SERVICE DIRECTIVE BULLETIN NO. 0127

Revision 2

1. SUBJECT: Rod End Inspection

2. MODEL: F-28, F-28A, F-28C, F-28C-2, F-28C-2R, F-28F, F-28F-R, 280, 280C, 280F,
 280FX

Figure 1. a) Rod end assembly (removed for clarity), area within the box is representative of photo b) and c) area); b) Airworthy rod end (as installed); c) unairworthy rod end with thread root corrosion

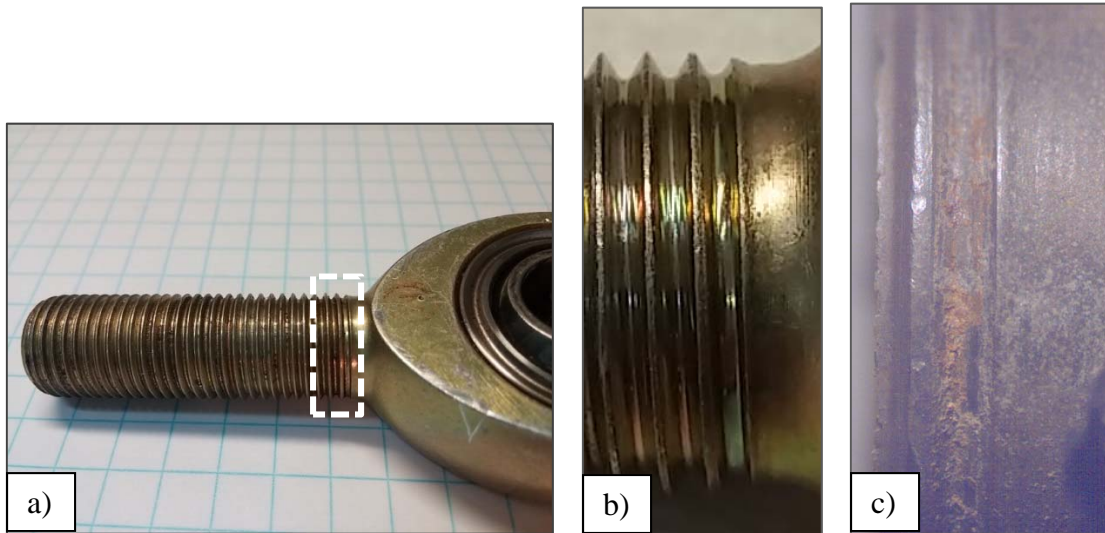
- 6.2.1 Disengage the clutch.
 - 6.2.2 Remove the cowling.
 - 6.2.3 Disconnect the rod end from the bellcrank.
 - 6.2.4 Pivot the idler pulley support to allow the rod end to clear the bellcrank.
 - 6.2.5 Remove the safety device and loosen the jam nut.
- 6.3 Turn the jam nut down to enable inspection of 1-inch of thread length from the shank of the banjo.
 - 6.4 Using a bright light source and magnifying glass (10X or greater), inspect for corrosion in the root of the thread (Figure 1c).

6.4.1 If corrosion is evident, replace the rod end before further flight.

6.4.1.1 Replace with an airworthy rod end treated with a corrosion inhibitor prior to installation (refer to paragraph 7 for parts). Apply the corrosion inhibitor in accordance with paragraph 6.5.

6.4.2 If no corrosion is evident, proceed to step 6.5.
